REZONING PLAT OF 5123 TIMBER RIDGE ROAD FOR:  
**FRANK D'ARIES**  
DEED BOOK 14808 PAGE 913

**PETITION NO:** Z-65

### **Z-65 FRANK D'ARIES**

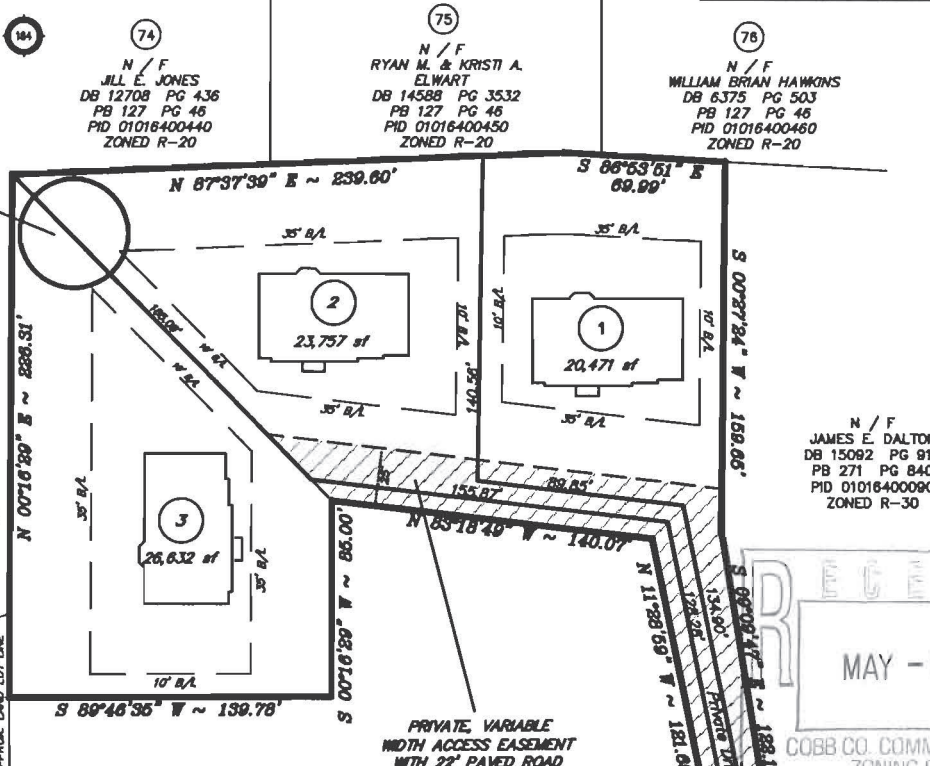
1. Waiving the required public road frontage from the required 75 feet to 25 feet for each proposed lot; and
2. Allowing the setbacks for Lot 3 to be arranged toward the private drive as shown on the proposed site plan.

Additional Private sewer for 3-member HOA (per application) is discouraged. Design alternatives can be evaluated at Plan Review.

- No Stormwater controls shown \_\_\_\_\_
- Copy of survey is not current – Additional comments may be forthcoming when current site conditions are exposed.
- No site improvements showing on exhibit.

1. Since the proposed development is creating 3 or more lots it must provide for full stormwater management for the site. A separate parcel must be provided for the stormwater management facility. Due to the parcel shape and topography this will require a downstream easement to accommodate a concentrated discharge that does not currently exist. If the facility is to be dedicated to the County for maintenance, the pond parcel must be accessed directly from the public right-of-way.

Timber Ridge Road is classified as a minor collector and according to the available information the existing right-of-way does not meet the minimum requirements for this classification.

Recommend applicant consider entering into a development agreement pursuant of O.C.G.A. 36-71-13 for dedication of the following system improvements to mitigate traffic concerns: a) donation of right-of-way on the north side of Timber Ridge Road, a minimum of 30' from the roadway centerline.

- A. It is Staff's opinion that the applicant's rezoning proposal may not permit a use that is suitable in view of the use and development of adjacent and nearby properties. Other properties in this area are developed subdivisions and single-family houses on larger lots, meeting public road frontage requirements.

- B. It is Staff's opinion that the applicant's rezoning proposal may have an adverse affect on the usability of adjacent or nearby property. Properties in developed subdivisions and the single-family lots in the area have public road frontage. The subject property, with enough public road frontage for one lot, was parceled out from a larger tract.

- E. It is Staff's opinion that there are existing and changing conditions affecting the use and development of the property which give supporting grounds for denying the applicant's rezoning proposal. The subject property was divided out from a larger tract and the fact that it had enough road frontage for one lot appears to have been the intent at the time of creating the current lot. While the proposed density is within the range for LDR and the requested R-20 zoning category is compatible with LDR, Staff believes the proposed development is out of character with other developments in the area because properties in those developments have public road frontage and other lots in the area that have less road frontage are single, larger lots.

Based on the above analysis, Staff recommends **DENIAL**.
